Access Compliance Report

Public Rights-of-Way

(Curb Ramps)

Intersection ID: 10033418	Main Street: OLD_HEBRON_RD	Cross Street: N/A	Location: SE
ADA ID: CD47BDDD16EF	Ramp Type: PerpDiag	Initial Pass/Fail: Fail	Overall Compliance: No
		Severity Score: 25

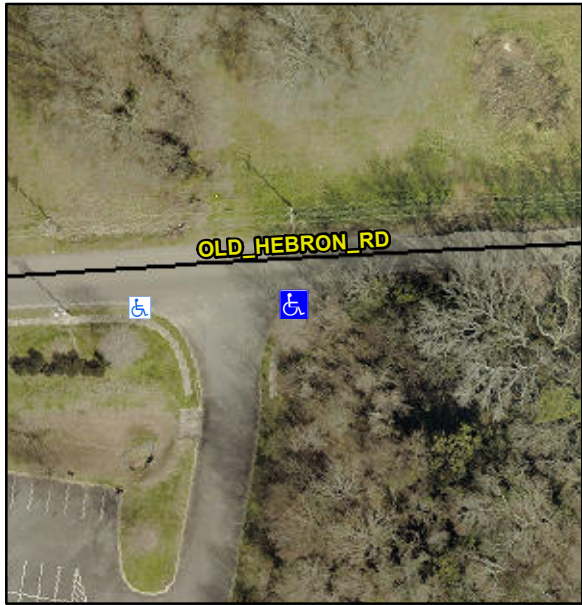
Codes/Mitigation Info/Possible Solution			Field Measurements/Component Compliance					
	Possible Solutions:		Compliance	Description	Data	Compliance	Description	Data
	Remove & Replace Curb Ramp With Two New Directional Ramps or Equivalent.		N/A	Ramp Length (in)	46.0	Yes	Ramp Slope (%)	6.2
			Yes	Ramp Width (in)	48.0	No	Ramp XSlope (%)	7.1
			N/A	Flare Type LT	N/A	N/A	Flare Type RT	N/A
			N/A	Flare Slope LT (%)	N/A	N/A	Flare Slope RT (%)	N/A
			N/A	Flare Traversable LT?	N/A	N/A	Flare Traversable RT?	N/A
			N/A	Landing Length (in)	N/A	N/A	DWS Provided?	N/A
			N/A	Landing Width (in)	N/A	N/A	DWS Contrast?	N/A
			N/A	Landing Slope (%)	N/A	N/A	DWS Length (in)	N/A
			N/A	Landing X Slope (%)	N/A	N/A	DWS Full Width?	N/A
Surveyor Notes:	N/A		N/A	Landing Curb? (Y/N)	N/A	N/A	DWS Offset (in)	N/A
			N/A	Shared Landing?	N/A			
			N/A	Gutter Ponding?	N/A	N/A	Gutter Slope (%)	N/A
			N/A	Gutter Lip Ht (in)	N/A	N/A	Gutter X Slope (%)	N/A

N/A	Painted X Walk1?	No	N/A	Painted X Walk2?	No
				X Walk 1 Direction	To N		X Walk 2 Direction	To W
			N/A	X Walk 1 Width (in)	N/A	N/A	X Walk 2 Width (in)	N/A
				X Walk 1 Slope (%)	0.3		X Walk 2 Slope (%)	2.5
				X Walk 1 X Slope (%)	2.8		X Walk 2 X Slope (%)	2.6
			N/A	Ramp inside XWalk1?	N/A	N/A	Ramp inside XWalk2?	N/A
PROW/ADA:	R304.5.3			Road Slope (%)	5.7	N/A	Clear Space?	N/A
				Road X Slope (%)	2.3	N/A	Clear Space to XWalk (in)	N/A
			N/A	Any Obstructions?	N/A	N/A	Storm Grate/Utility Hazard?	N/A
				Obstruction Type			Storm Grate/Utility Type	
						N/A		N/A
						Yes	Surface Condition? (G/P)	Good
	Total Cost:		\$	3200.00
